Access Compliance Report Public Rights-of-Way (Curb Ramps)

Intersection ID: 10023414	Main Street: CHOATE_CR	Cross Street: N/A	Location: W
ADA ID: D4730DBB3B4D	Ramp Type: BlendTrans2	Initial Pass/Fail: Fail	Overall Compliance: No
Codes/Mitigation Info/Possible Solution			Severity Score: 10
		Field Measurements/Component Compliance

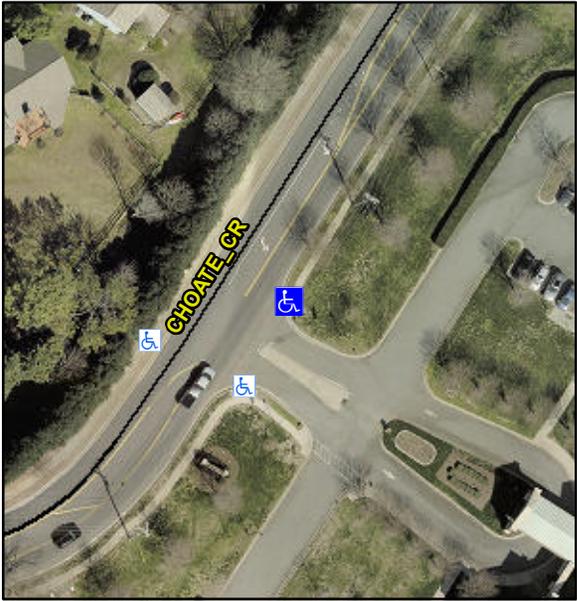
PROW/ADA:
R304.5.1, R304.5.3

Compliance	Description	Data	Compliance	Description	Data
N/A	Ramp Length (in)	96.0	Yes	BlendTrans Slope (%)	4.5
No	Ramp Width (in)	37.5	No	BlendTrans XSlope (%)	3.8
N/A	Flare Type LT	N/A	N/A	Flare Type RT	N/A
N/A	Flare Slope LT (%)	N/A	N/A	Flare Slope RT (%)	N/A
N/A	Flare Traversable LT?	N/A	N/A	Flare Traversable RT?	N/A
N/A	Landing Length (in)	N/A	N/A	DWS Provided?	N/A
N/A	Landing Width (in)	N/A	N/A	DWS Contrast?	N/A
N/A	Landing Slope (%)	N/A	N/A	DWS Length (in)	N/A
N/A	Landing X Slope (%)	N/A	N/A	DWS Full Width?	N/A
N/A	Landing Curb? (Y/N)	N/A	N/A	DWS Offset (in)	N/A
N/A	Shared Landing?	N/A			
N/A	Gutter Ponding?	N/A	N/A	Gutter Slope (%)	N/A
N/A	Gutter Lip Ht (in)	N/A	N/A	Gutter X Slope (%)	N/A
N/A	Painted X Walk1?	No	N/A	Painted X Walk2?	No
	X Walk 1 Direction	To NW		X Walk 2 Direction	To SW
	X Walk 1 Width (in)	N/A		X Walk 2 Width (in)	N/A
	X Walk 1 Slope (%)	10.8		X Walk 2 Slope (%)	5.1
	X Walk 1 X Slope (%)	3.2		X Walk 2 X Slope (%)	3.9

Possible Solutions:
Remove & Replace Curb Ramp With Two New Directional Ramps or Equivalent.
